From: SCHNEIDER Shane J <Shane.SCHNEIDER@rms.nsw.gov.au>
To: Sara Roach <Sara.Roach@planning.nsw.gov.au>
CC: Mark Millington <Mark.Millington@rms.nsw.gov.au>
Date: 8/6/2013 1:16 pm
Subject: RE: MP06_0162 MOD 6- Modification to Concept Plan for Barangaroo South
Attachments: BFI design Option 2 RL 2 9 at 30 deg angle pdf pdf.pdf

Section 75W Modification Application
Modifications to Concept Plan for Barangaroo South (MP06_0162 MOD 6)

BARANGAROO FERRY TERMINAL
OPTION 2.30 RL2.900 RECTANGULAR PONTOONS

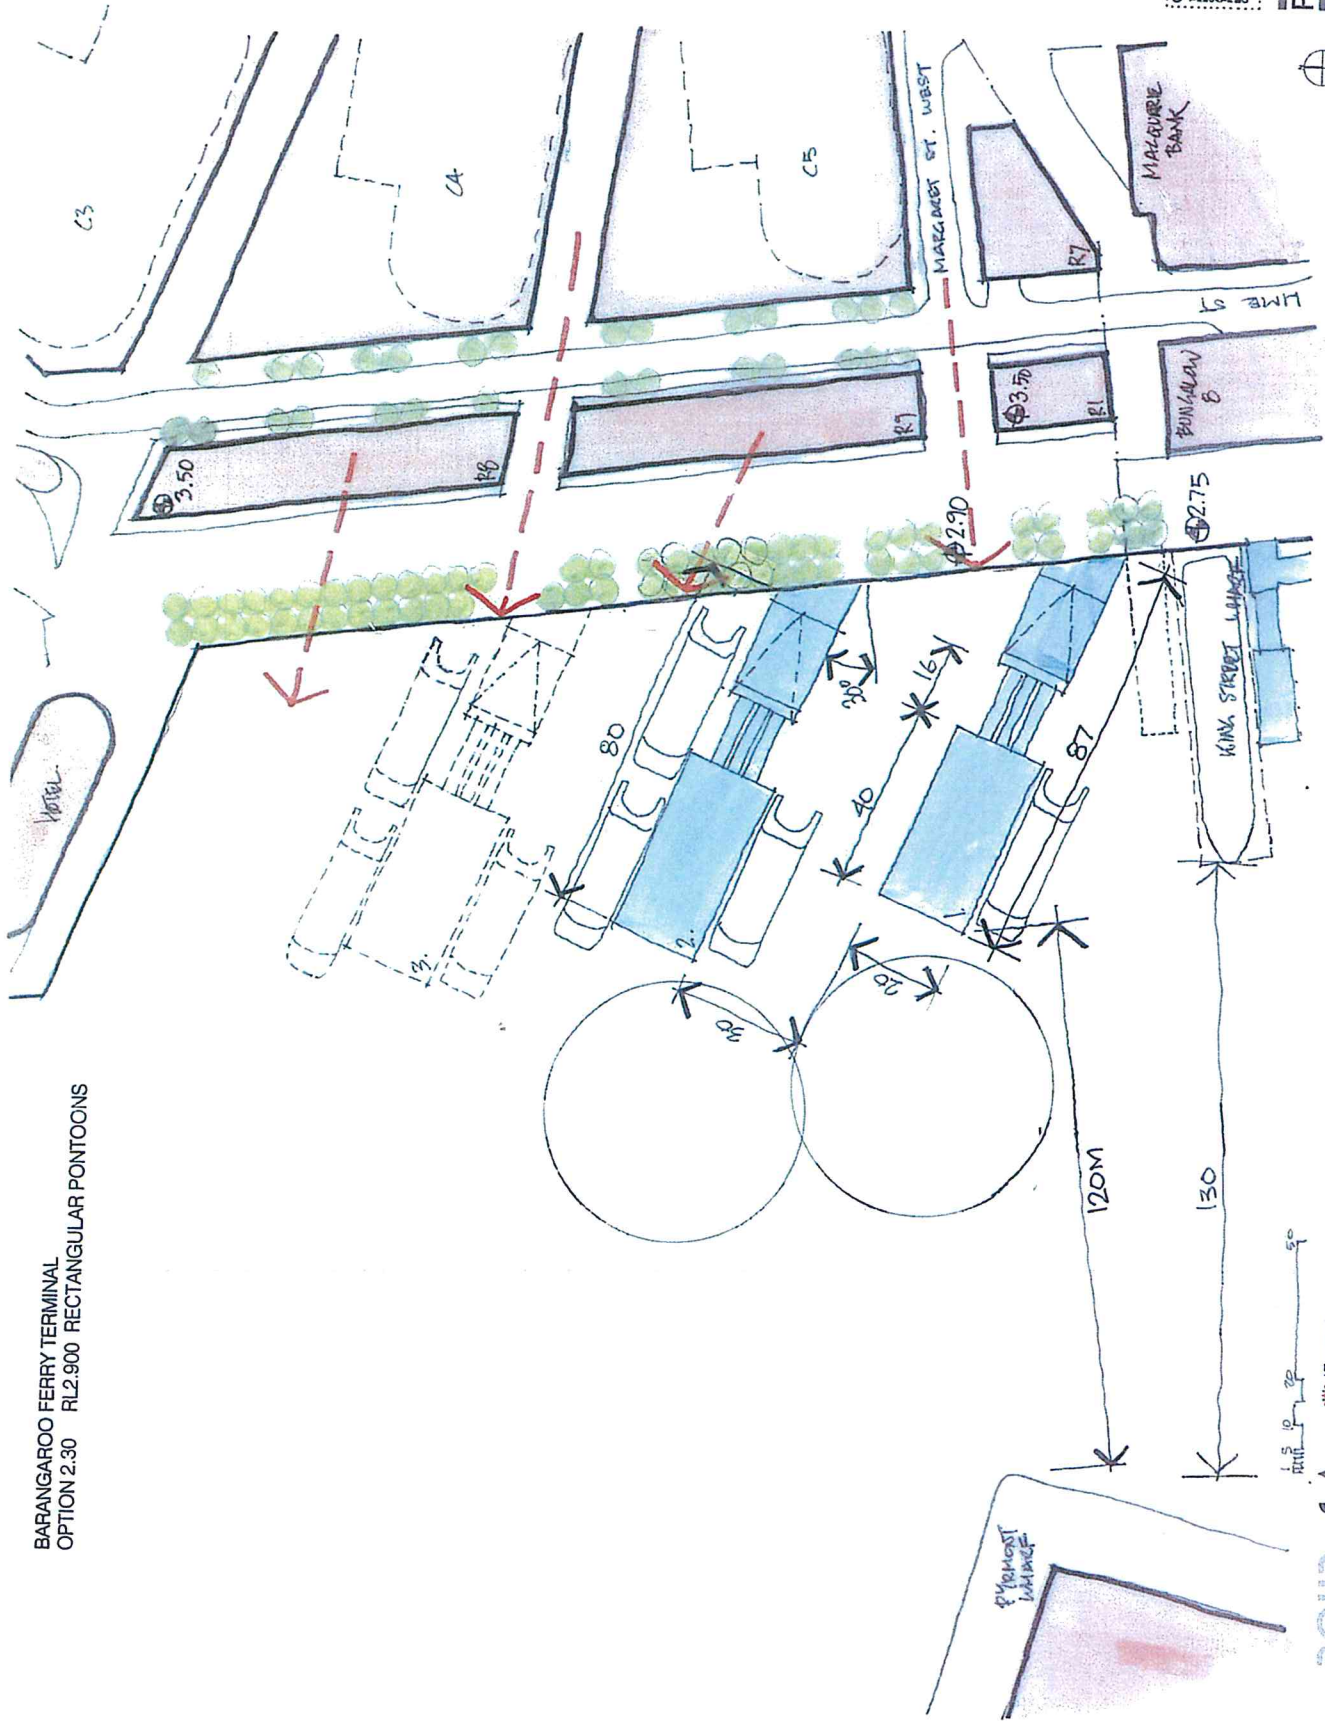
8. The design of the proposed Barangaroo Ferry Interchange was amended in 2012. Ferry wharves were originally designed to be perpendicular to the sea wall. It is understood that Transport for NSW and the Barangaroo Delivery Authority agreed to an amended design such that ferry wharves are offset at an angle of 30 degrees from perpendicular to improve navigation safety at what is a pinch point in Darling Harbour as shown on the attached plan (BFT Option 2.30). This attached plan shows a finished level for the waterfront promenade in the vicinity of the ferry wharves of RL2.9. The highest level that will enable safe mobility access to the wharves at low tide without increasing their length and creating further constraints to safe navigation in Darling Harbour is RL2.9.

Some of the plans provided in the submission show the amended layout but others, such as the indicative drawings in Appendix B and the urban design drawings in Appendix C, show the original perpendicular layout. RMS requests

that all future plans show the agreed amended design.
